City of El Paso - City Plan Commission Staff Report

Case No: SUSU17-00075 Karla Gonzo Medical Buildings

Application Type: Major Combination **CPC Hearing Date:** October 19, 2017

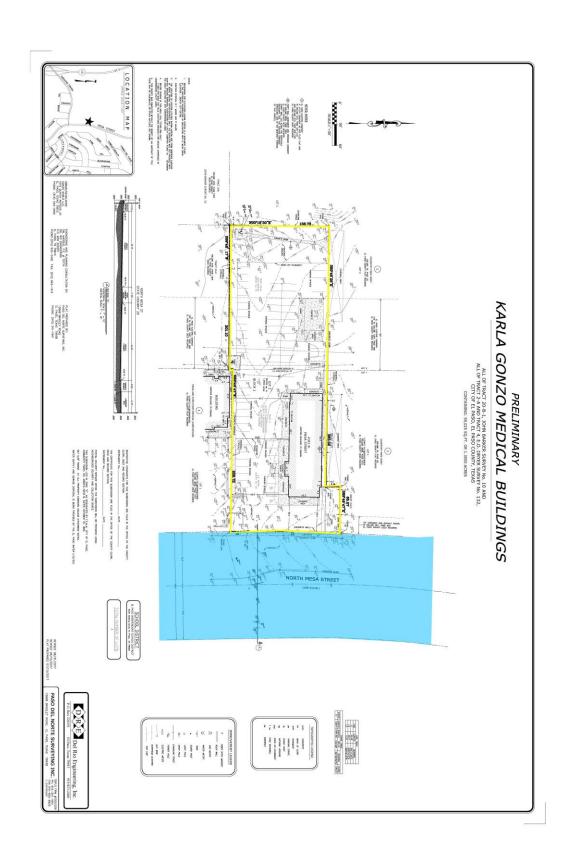
- 1. The subdivision shall be tied by bearing and distance to either a section corner, a survey line, a grant line, or other known and accepted survey points delineated on the final plat by bearing and distance within three thousand feet.
- 2. Storm-sewer system discharge velocity into the arroyo shall not exceed 6 ft/s.
- 3. Driveway cross slope must be in compliance with ADA and TAS standards.

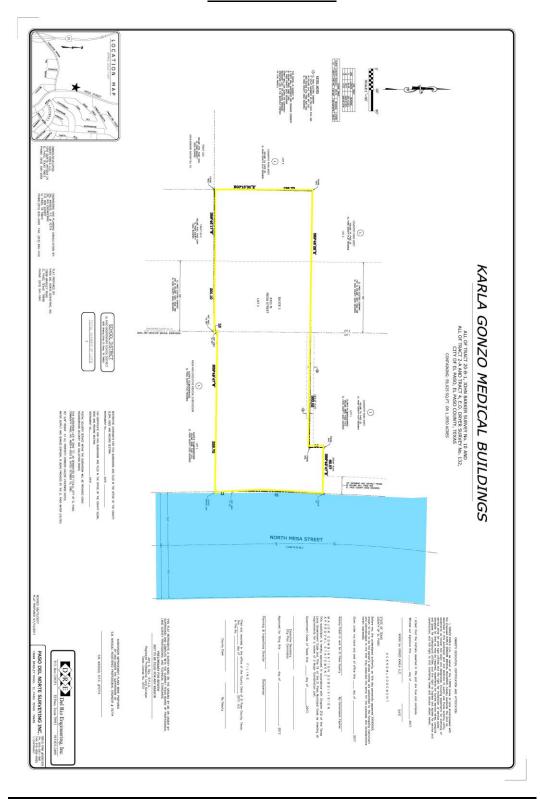
TxDot do not request a hike and bike at this time just a 5-ft sidewalk.
